TECHNICAL SERVICE BULLETIN		
ISSUE DAT	FE: 04/15/20	TSB NUMBER: TSB-202
HAZARD / URGENCY RATING		
Х	DANGER - Physical harm is possible if TSB is not observed or followed	
X	WARNING - Equipment damage is possible if TSB is not observed or followed	
Х	CAUTION - Essential issue affecting operation, service, parts or installation	
Х	INFORMATIONAL - Advisory which may be of interest

ALL ROAD VEHICLES USING RAFNA RAIL GEAR WITH A R-460 REAR UNIT INSTALLED

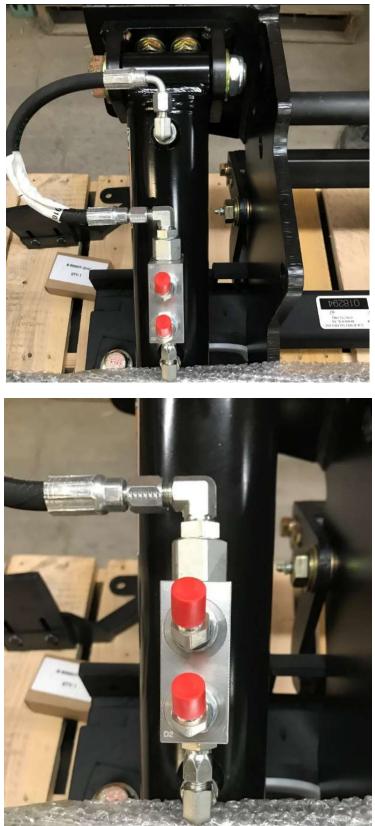
THE ORIENTATION OF THE PO CHECK VALVES ON THE CYLINDER MAY BE REVERSED. THIS WOULD BE "LOCKING" THE FLUID WHEN IT IS IN THE ROAD POSITION AND NOT THE RAIL.

IMPROPER ORIENTATION OF THE PO CHECK VALVE REMOVES THE SECONDARY FAIL SAFE WHEN THE GEAR IS IN THE RAIL POSITION AND GIVES THE GEAR THE POTENTIAL TO COLLAPSE IN THE CASE OF A HYDRAULIC FAILURE.

- 1. LOCATE THE PO CHECK VALVE.
- 2. INSPECT ORIENTATION OF THE CHECK VALVE. CHECK VALVE SHOULD ALWAYS BE CONNECTED TO THE BLIND PORT OF THE CYLINDER.
- 3. IF THIS IS NOT THE CASE, ENSURE THE RAIL GEAR IS LOCKED IN THE ROAD POSITION OR SUPPORTED. REMOVE THE CHECK VALVE AND ORIENT CORRECTLY IN ORDER TO ENSURE THE SECONDARY LOCKING SYSTEM WILL FUNCTION PROPERLY IN THE CASE OF HYDRAULIC FAILURE. (SEE PHOTOS BELOW FOR VISUAL AID AND CORRECT ORIENTATION)
- 4. ONCE CORRECTLY ORIENTED, ENSURE ALL HYDRAULIC FITTINGS ARE TIGHT THAT HAD TO BE LOOSENED.
- 5. ROTATE THE RAIL GEAR BETWEEN THE ROAD AND RAIL POSITIONS, CHECKING FOR HYDRAULIC LEAKS AND ANY INTERFERENCE/RUBBING OF THE VALVE OR HOSE.
- 6. CHECK HYDRAULIC FLUID LEVELS AND TOP OFF IF NEED BE FROM LOSS.
- 7. VEHICLE CAN NOW BE USED AS USUAL.
